Planning Application PL/2023/06122
Class Q Change of use of Agricultural Building to 5 no. Dwellinghouses
Pickers Palmers Farm, Capps Lane, Heywood, Westbury, BA13 4NE

Introduction

Date	Scale	Size
AUG 2023	1:150	A1
Drawing No.	Rev	
NJC-001	-

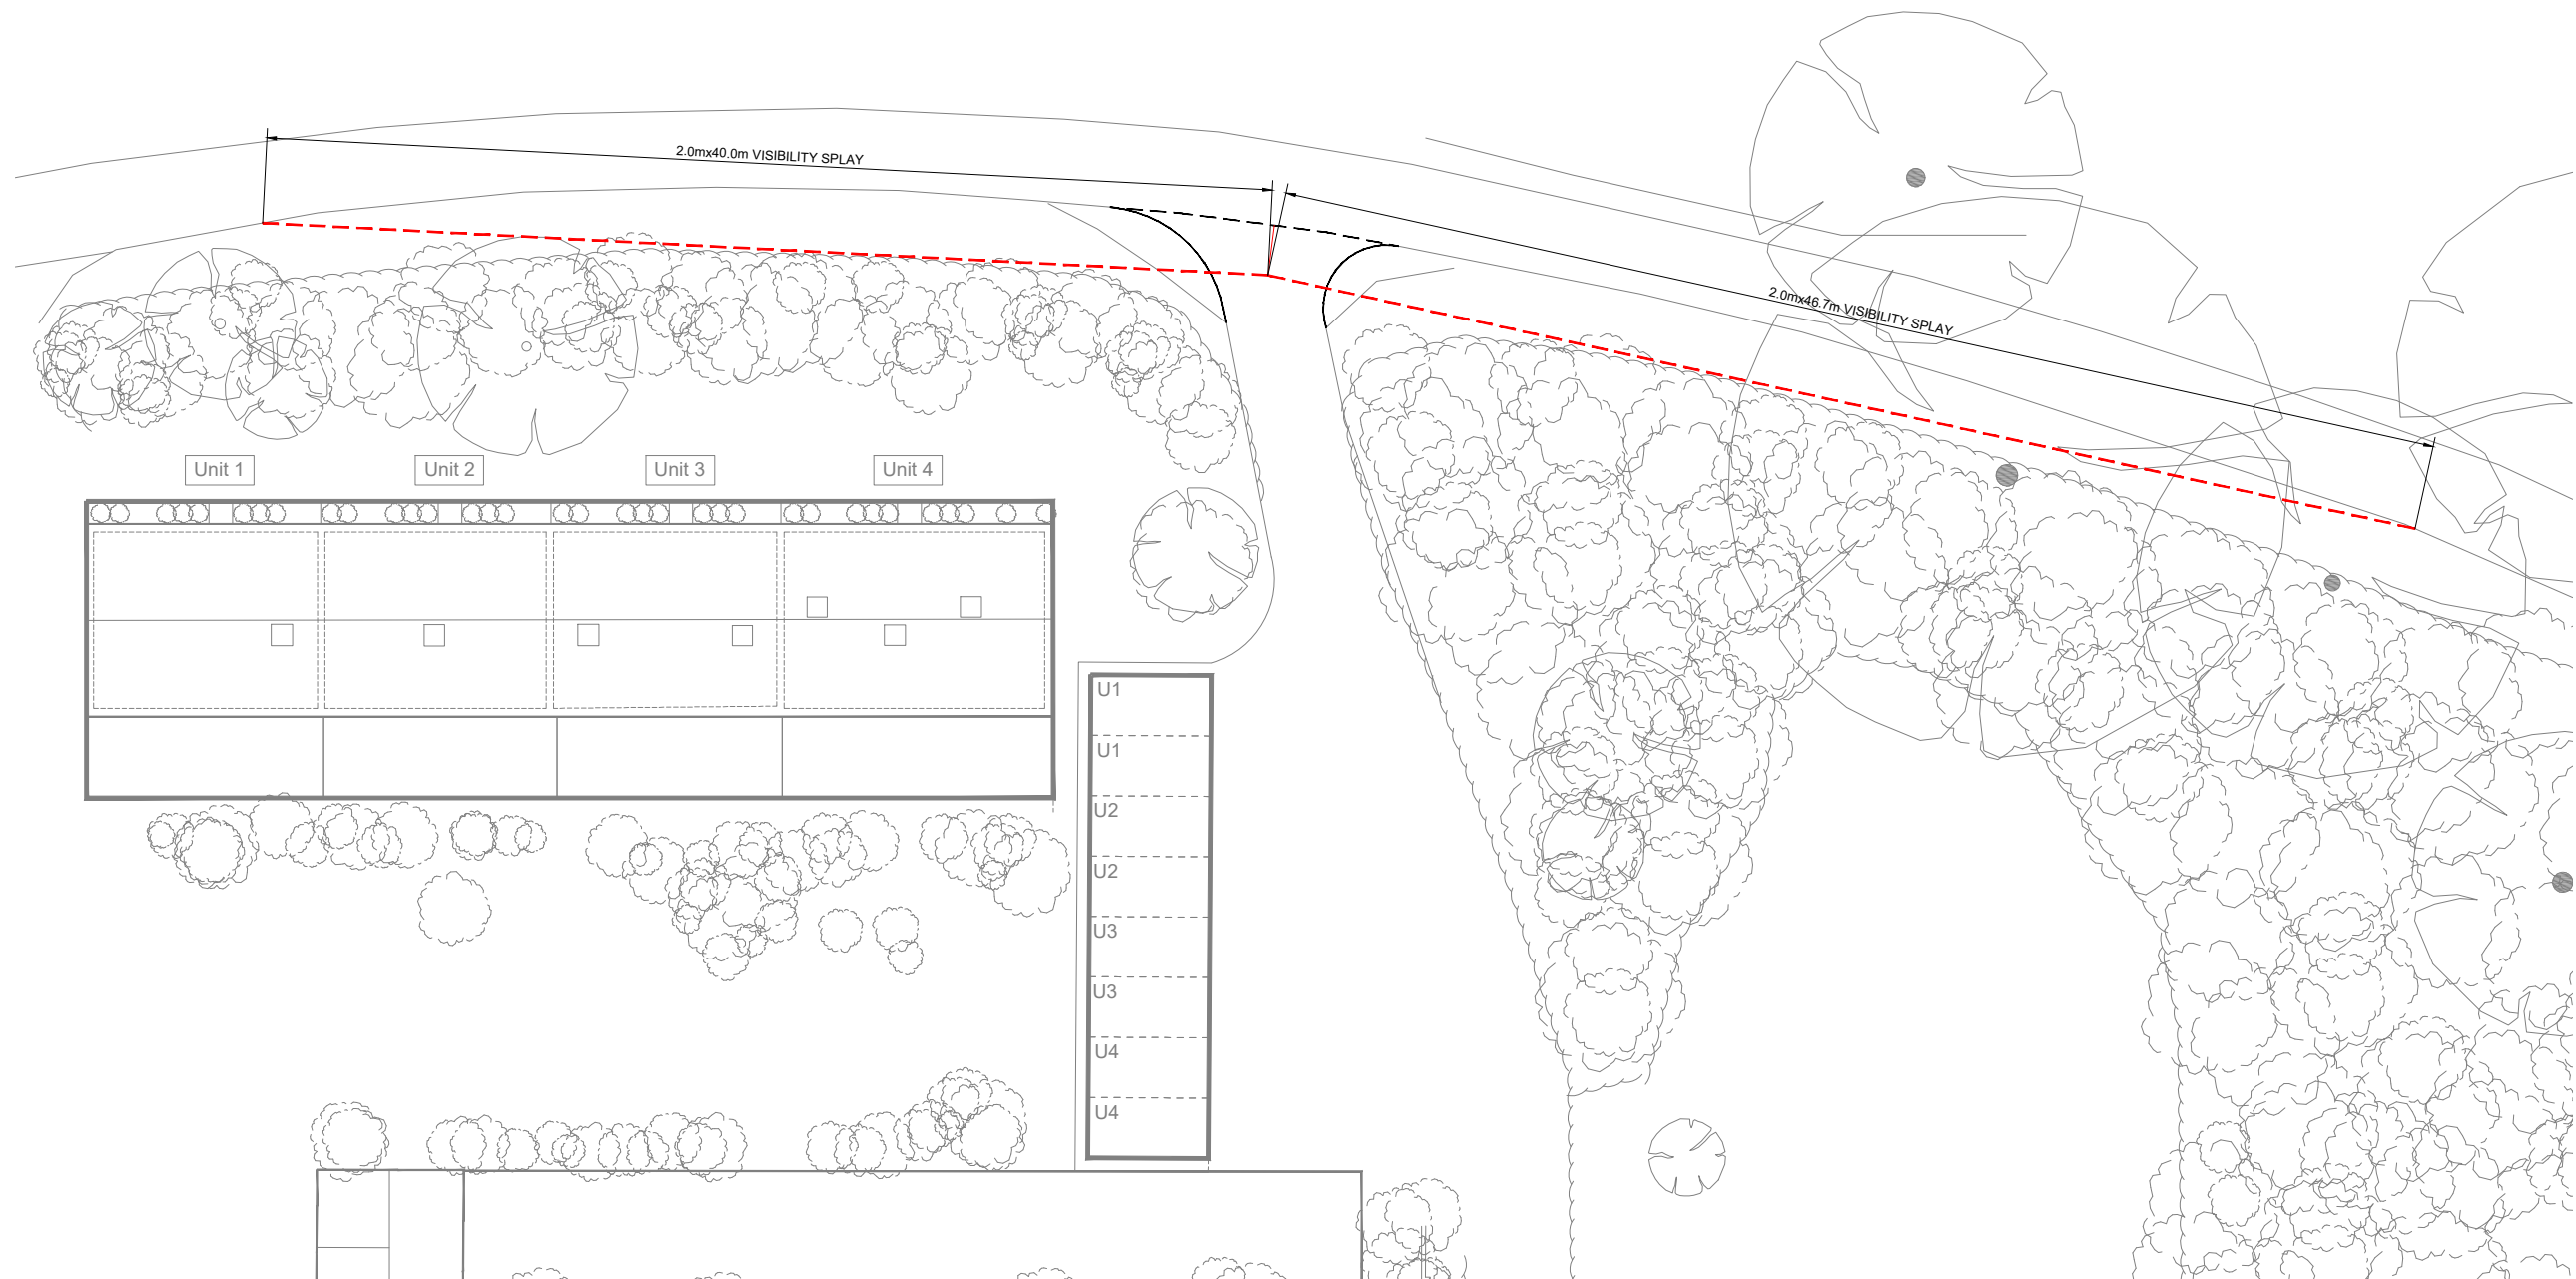
The proposed site access, whilst existing, is poorly formed, overgrown and with a loose/unmade surface, which would not be suitable to serve residential development without improvement. It is also clear that vegetation restricts visibility at the existing access during high growth seasons and the available visibility is thus difficult to assess. Whilst the extant uses on site would generate a level of traffic, other agricultural buildings remain present on site, thus meaning that such uses can continue in addition to that of the new dwellings. Furthermore, the presence of other buildings also presents the possibility of further residential conversions on the site, further increasing traffic along Capps Lane, which is substandard in terms of width and lacking any pedestrian facilities and street lighting.

As a result, if you are minded to accept the principle of these proposals, I will require additional information in respect to the extant agricultural use of the site, including that of traffic movements, the proposed ongoing uses of the other buildings on the site and a revised/additional plan showing the below access, prior to forming a formal Highway position on these proposals;

- *Maximum available visibility splays based on a setback of 2.4m.*
- *Minimum access width of 5m over the first 10m of the access.*
- *A consolidated surface over the first 5m of the access.*
- *An unallocated visitor car parking spaces provided within the site.*

Notwithstanding the above, the Highway Officer has requested that a plan be submitted showing the maximum available visibility splays based on a setback of 2.4m, a minimum access width of 5m over the first 10m of the access and a consolidated surface over the first 5m of the access.

Drawing numbered NJC-001 is included as **Appendix 1** to this Note which shows the access which can be improved to provide formal radii, with an access road width of 5.0m. The first 5.0m can be surfaced in a non-migratory material, and a suitable condition can be imposed that requires these improvements to be implemented before first occupation of any of the dwellings.

With regards to the available visibility, the drawing shows splays of 2.0m by 40.0m to the west and 2.0m by 46.7m to the east.

Manual for streets 2, in paragraph 10.5.8 says:

“A minimum X distance of 2.0m may be considered in some slow speed situations when flows on the minor arm are low. This also applies in lightly trafficked rural lanes.”

As Capps Lane is a lightly trafficked rural lane, it is therefore reasonable to apply a 2.0m X distance in this instance.

Based on the available splays of 40, and 47m respectively, this relates to traffic speeds on Capps Lane of around 29 to 32mph, which is considered to be reasonable.
